October 24, 2016

Re: Response to Ecology's *Opinion Pursuant to WAC 173-340-515(5) on Remedial Action for the Following Hazardous Waste Site:*

Site Name: Lake Goodwin Store 2013
Address: 4726 Lakewood Road, Stanwood, WA 98292
Facility/Site No.: 12889948
Cleanup Site ID No.: 12352
VCP No.: NW2974

SURFICAL &
 SUBSURFACE
 WATER
 FEATURES
 FIGURE 1

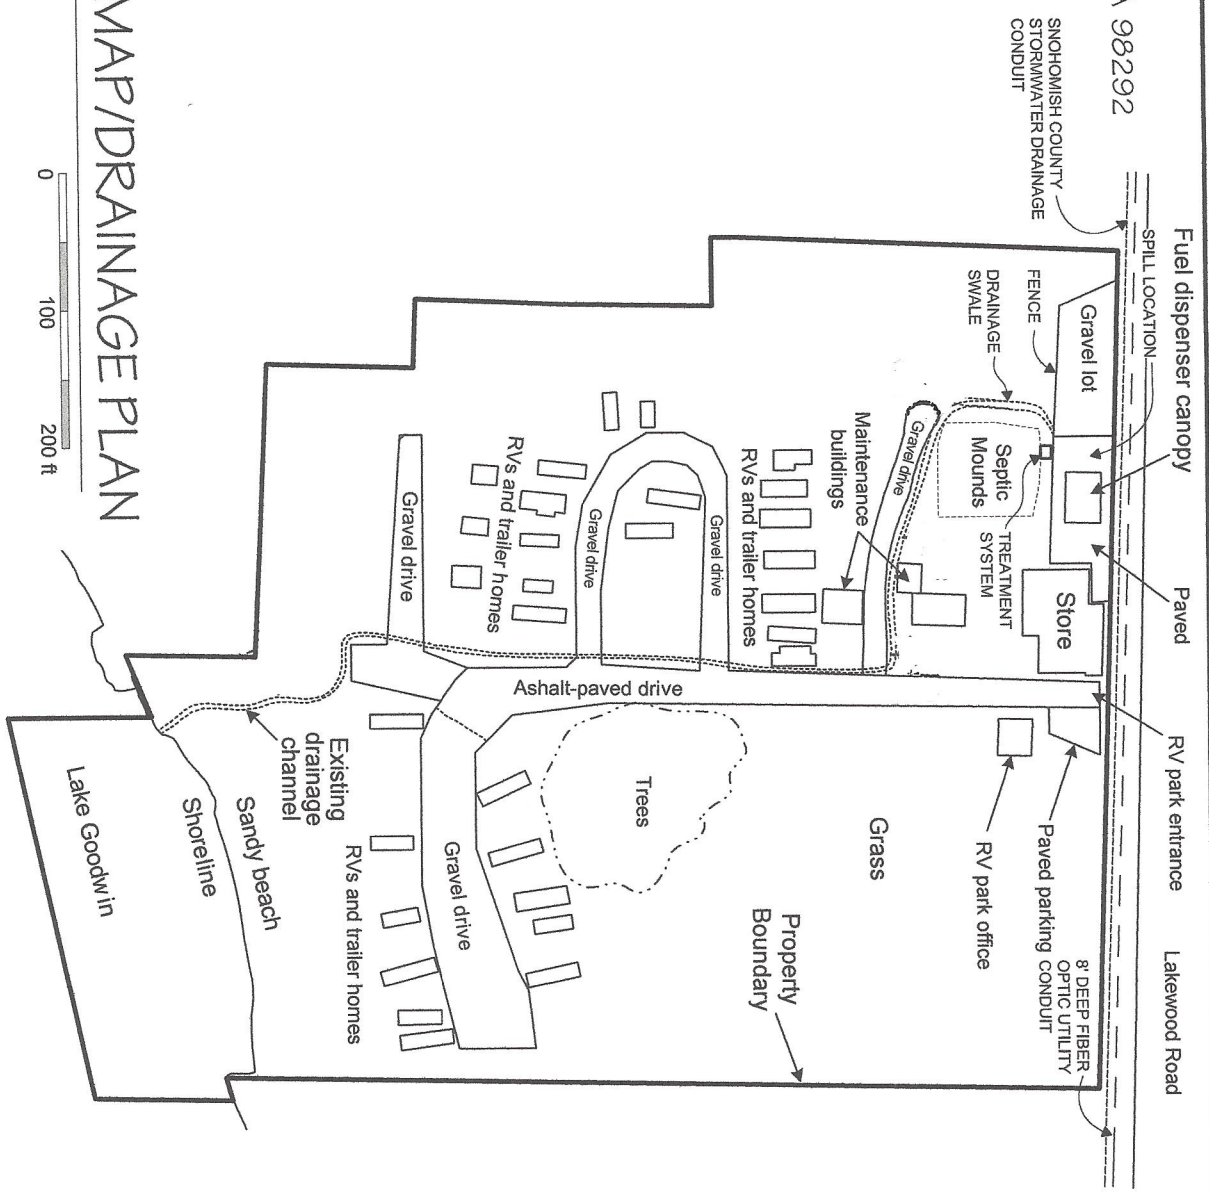
- *A Site conceptual model needs to be developed that shows how and where the TPH-g and BTEX release likely migrated after entering the subsurface. It is unlikely that TPH-g impacts to soil were limited to the upper one foot based on the ground water impacts identified in up gradient monitoring well MW-5 and cross gradient well MW-4. Based on the location of the release, estimated ground water flow direction and the location of PW-1, it is unclear how MW-5 was impacted by this release.*

- *All Site plans and diagrams need to include an accurate scale. The Site maps provided in all submitted reports do not meet this minimum requirement.*

The remaining volume of the spill flowed across the asphalt lined surface of the facility, and was brushed by the fuel supplier's driver into the grass-lined swale south of the gas station. Figure 1.

Additional data and analysis are presented in this letter that address the CSM elements necessary to respond to Ecology's comment. In response to the above comment, however, SD&C has prepared Site map/drainage plan (Figure 1) that illustrates the numerous influences on the shallow groundwater flow at the Site. The shallow groundwater in the spill area is influenced by the Snohomish County storm water drainage utility, 8 ft. deep optical fiber vault, the PW-1 pumping well, and mounding from the RV site septic field. SD&C has also tabulated the results of groundwater monitoring data collected from the wells since May 13, 2014 and prepared figures (Figures 3a,b,c/2014, and Figures 4a,b,c,d/2015 and Figure 4e/2016) that illustrate the change of direction in shallow groundwater.

Figure 1 attached to this letter illustrates the localized surficial and shallow subsurface utilities that impact the shallow groundwater flow at the Site. The Site is located in a topographical valley between two hill slopes. The surface geology consists of porous media (sand and gravel), which are underlain by dense glacial till of low permeability, creating a ponding effect near the surface. The Snohomish County PUD installed a surface water diversion conduit bordering the northern property boundary in 2012. Prior to that time there was reportedly frequent flooding at the Site. Further north of the surface water drain is a deep concrete fiber optic utility vault with an 8 ft. internal depth, and concrete foundation that likely extends to 10 ft. depth, which parallels the entire northern portion of the property line. The fiber optic utility vault would very likely trap PHCs released to groundwater on the Site and impede the release from flowing in a northerly direction. An 8" diameter water main transects the property directly through the Site and is reported to be less than 5 ft. below ground surface. There is a septic mound system for the RV Park, which is located, and discharges, directly southeast of the Site.

SAMPLE LOCATION MAP

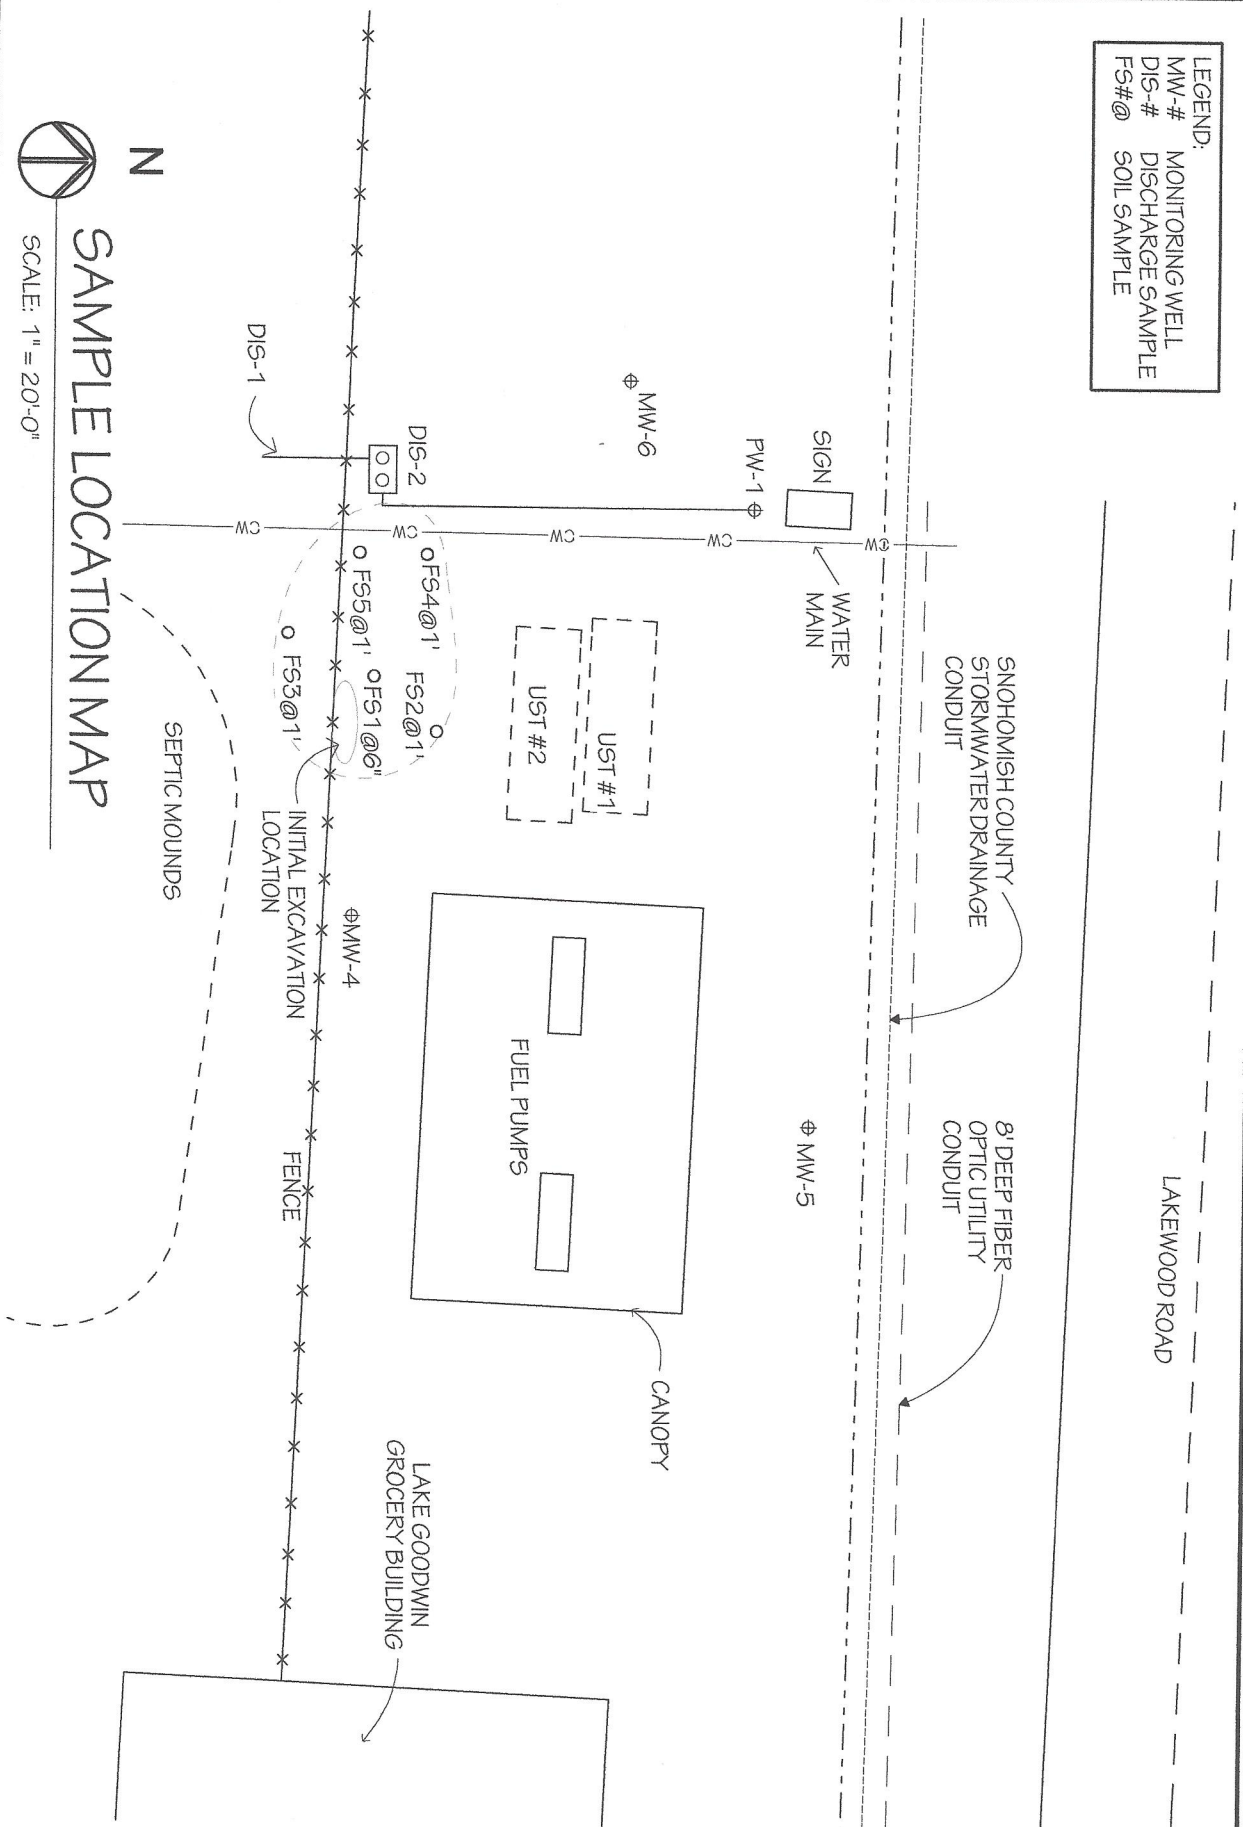
- *Pumping well PW-1 discharged approximately 45,000 gallons of petroleum contaminated ground water into the grassy area to the south of the underground storage tanks (USTs) over the nine-day period between when the release occurred and when LNAPL was pumped out of PW-1 (assuming a discharge rate of 5,000 gallons per day). The TPH-g and BTEX concentrations in the initial soil samples collected from locations FS 1 and FS2 at depths of six inches and one foot bgs respectively exceeded the MTCA Method A cleanup level. The vertical and lateral extent of contamination was not delineated. The excavation confirmation samples FS3, FS4 and FS5, which were all collected at a depth of one foot bgs, were not placed appropriately to confirm that all contaminated soil has been removed. Samples should have been collected from the base of the excavation, below the depth of any confirmed exceedances and from the sidewalls of the excavation. The vertical and lateral (eastern) extent of contamination identified at boring location FS-1 needs to be determined. The vertical and lateral (western and southern) extent of contamination identified at boring location FS-2 needs to be determined. As noted above, the Site conceptual model needs to explain contaminant migration. The Site conceptual model should illustrate the likely path the 45,000 gallons of water would take that was discharged to the grassy area.*

The samples FS-1 and FS-2 were collected in the swale by SD&C when they arrived on site after NRC conducted the emergency response to the spill Figure 2. The data indicated additional remedial actions were necessary to clean up the soil in the grassy swale, and generally downgradient of the surface spill. Thus, further excavation of impacted soil was conducted in an 800 square foot area, in the grass and beneath the asphalt downgradient of the spill area. The confirmation samples (FS3, FS4, and FS5) were collected from the side walls of the excavation just above the groundwater level at 1-1.5 feet below ground surface. The results of the soil samples and visual observations in the field indicated that the excavation and removal of soil was effective at removing impacted soil exceeding the MTCA Method A cleanup levels. Figure 2 attached to this letter illustrates the excavation location and sample locations. Photo documentation of the shallow excavation is also presented in SD&C's Soil Excavation and Remediation Report dated September 14, 2015.

FIGURE 3a

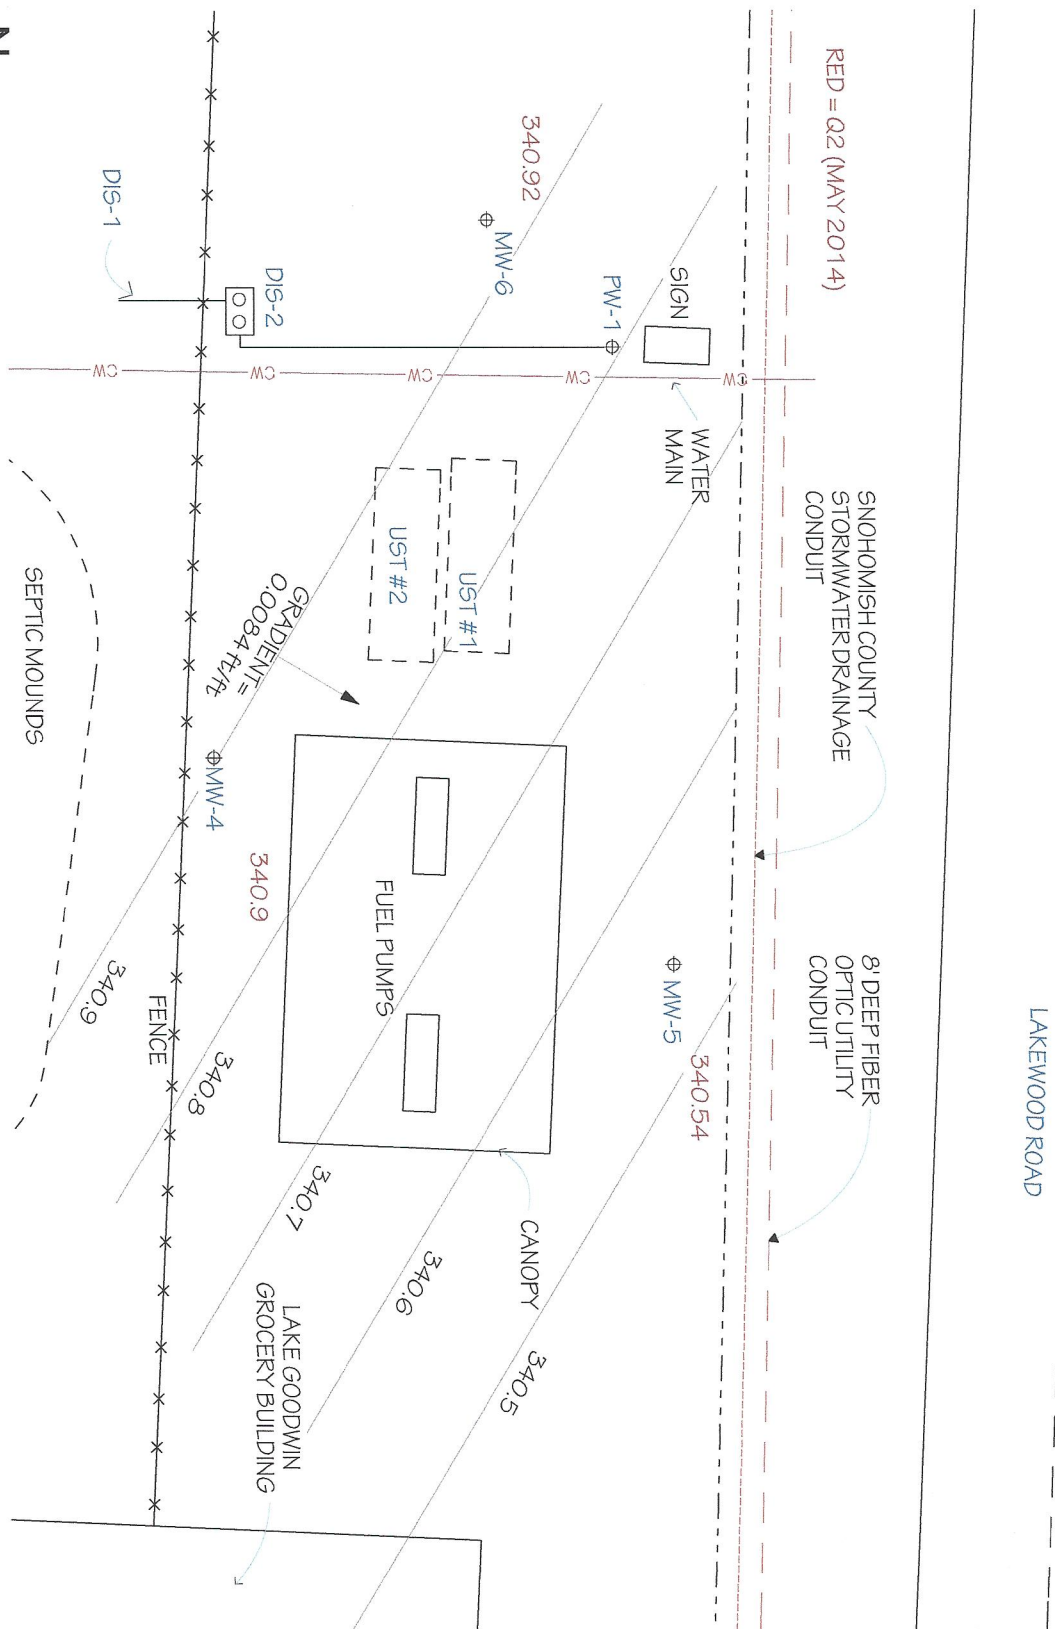
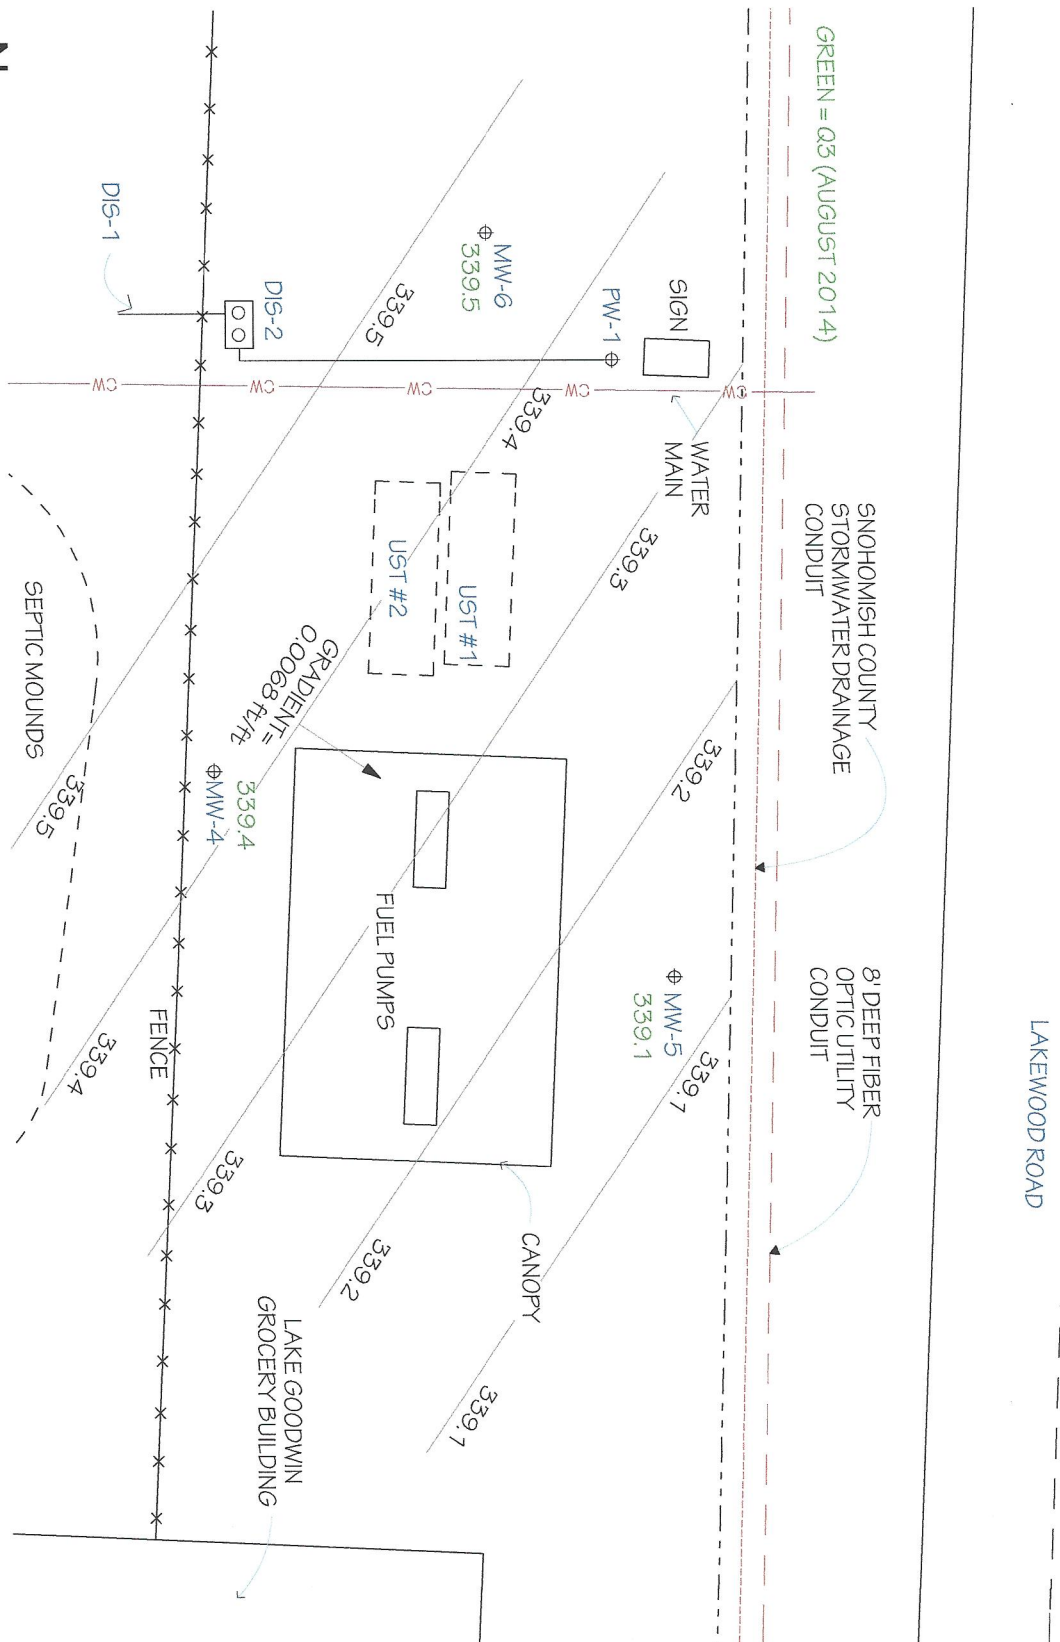
- *A ground water elevation contour map needs to be provided for each quarterly monitoring event.*

The quarterly water level elevation data is summarized on the attached Figures 3a,b,c/2014, Figures 4a,b,c,d/2015, 4e/2016.
